MIL-F-50541A (AR)
AMENDMENT 3
09 February 1990
SUPERSEDING
AMENDMENT 2
17 June 1980

MILITARY SPECIFICATION

FUZE FOR FLECHETTE WARHEAD, WDU-4A/A (LESS EXPULSION CHARGE)

FIGURE 1. Helicopter vibration

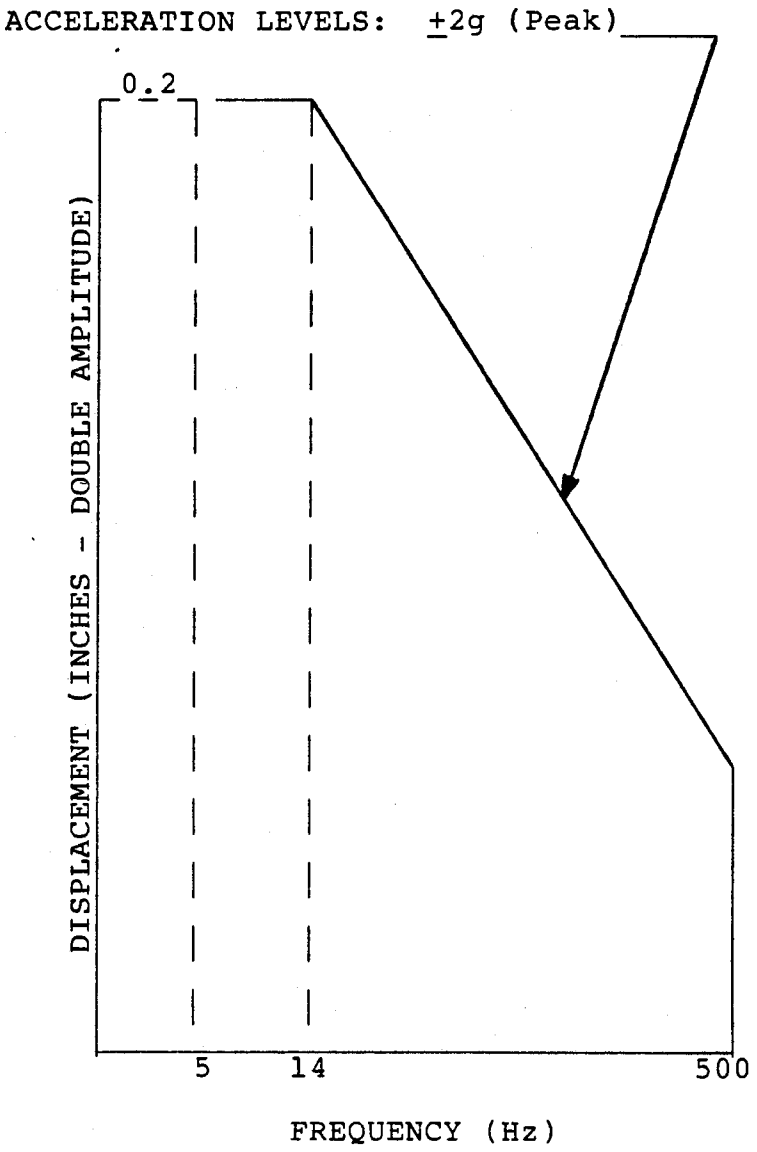
Delete Appendix A in its entirety and substitute enclosed Figure 1.

One 15 minute sinusoidal sweep (5-500-5 Hz) shall be performed for each of three axes. No dwell time shall be spent on any one frequency. A search for resonance shall not be done.
